## 工程指示 / 要求簡箋(E.I.)

工程指示編號：EI / 1462 / 20

工程名稱：觀塘裕民坊

工程項目：後裝窗拆圖 (28/F)

# 28/F PART PLAN

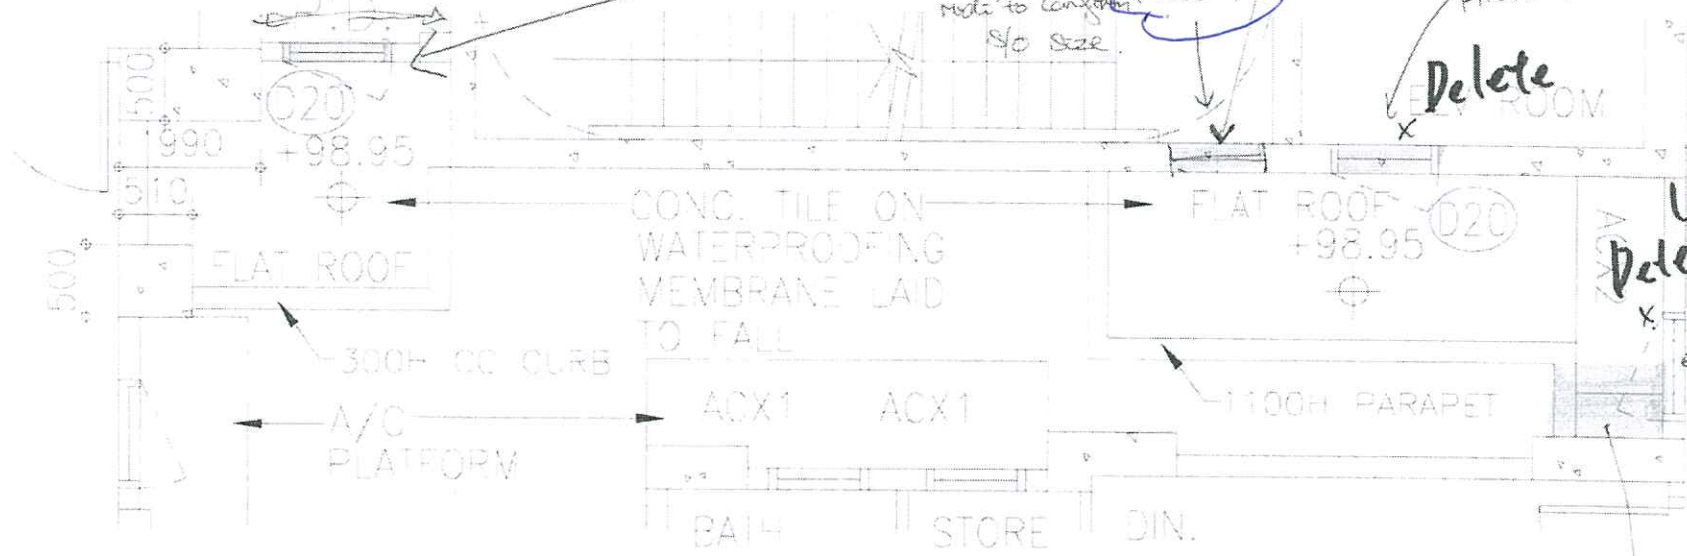
change to a removable lower by Mylet 850<sup>H</sup> x 500<sup>W</sup>

Existing lower.  
1000mm (h) x 700mm (w)  
Clear  
Note to conform to size.

CR-check as-built S/O  
Medi-Operable window  
(Frosted)  
CR-1 hr FRR format.

Delete

DELETE ROOM

Keep this window  
permanent lock.

請按資料提供拆圖T2 28/F 位置，防火窗改後裝窗(Access Panel)謝謝！請在 2020 / 01 / 28 前完成上列要求。

DWG NO. : JB37-IW-2214 REV. : A

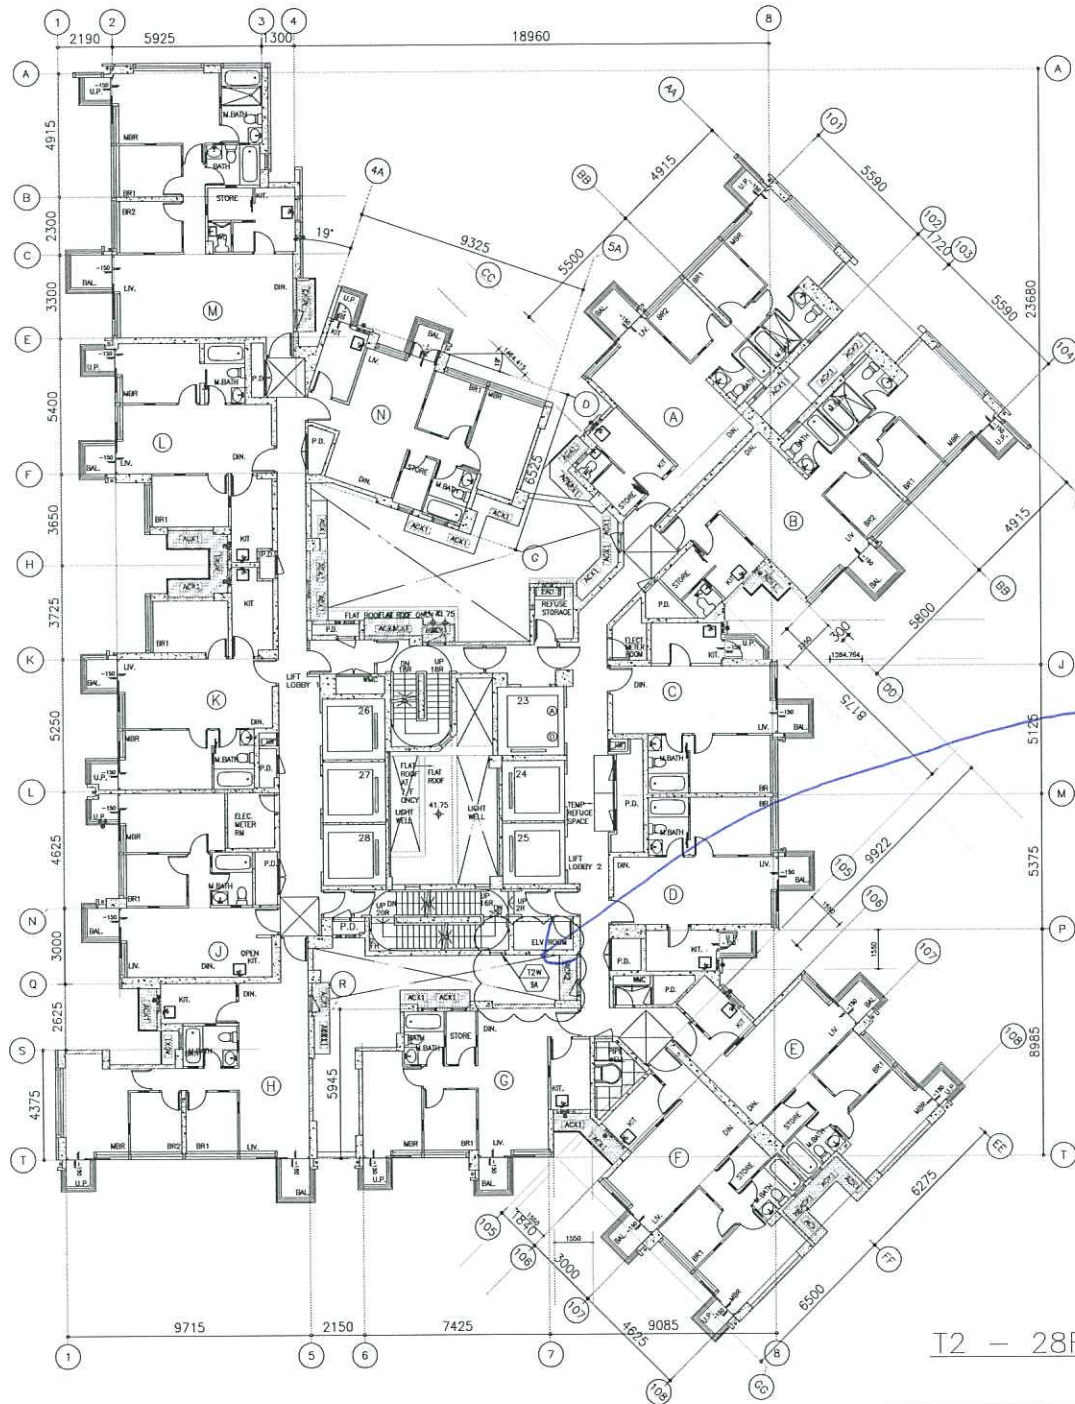
A	2019/12/12	BY ARCHITECT COMMON	Zeng
NO.	DATE	REVISED	BY
